## R E M A R K S

**AMENDMENTS TO THE DRAWINGS**

Annotated Marked-Up Drawings

FIG. 2

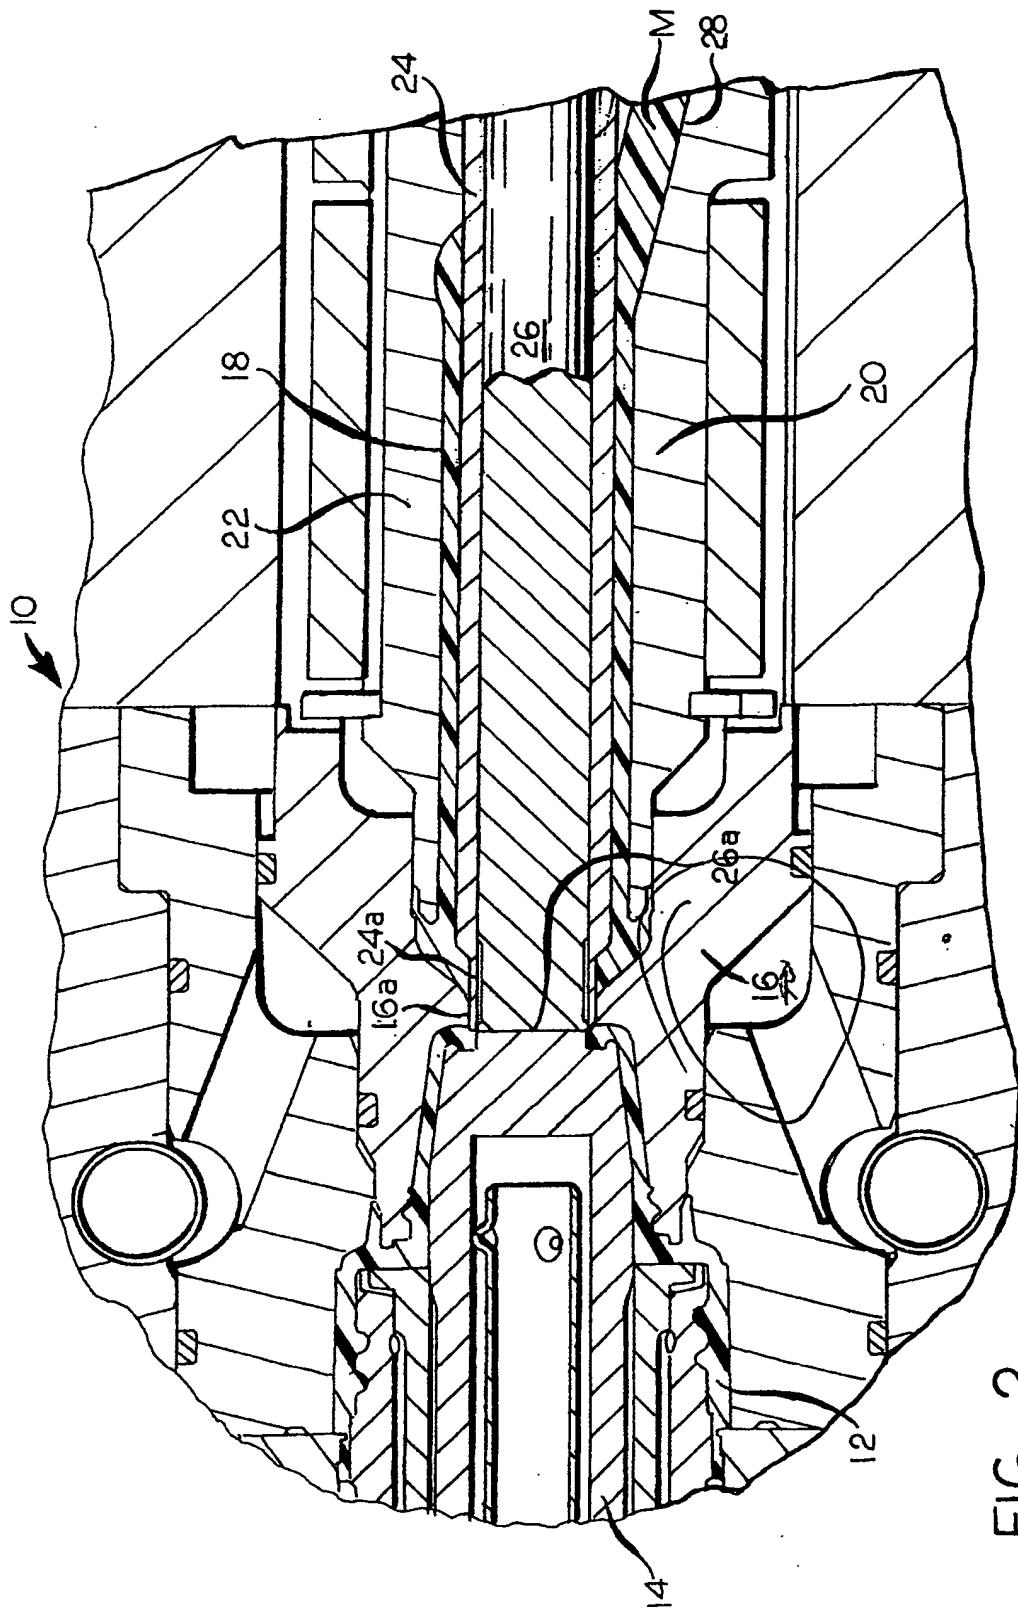
The foregoing amendments to the specification and drawings implement reference numeral corrections and define the meaning of the term "fixed" with reference to pin 26 in FIG. 2 (and pin 126 in FIGS. 3 and 4). Such amendments are fully supported by the application as filed. No new matter is presented.

Also enclosed are Annotated Marked-up Drawings showing the reference numeral corrections to FIGS. 2-4.
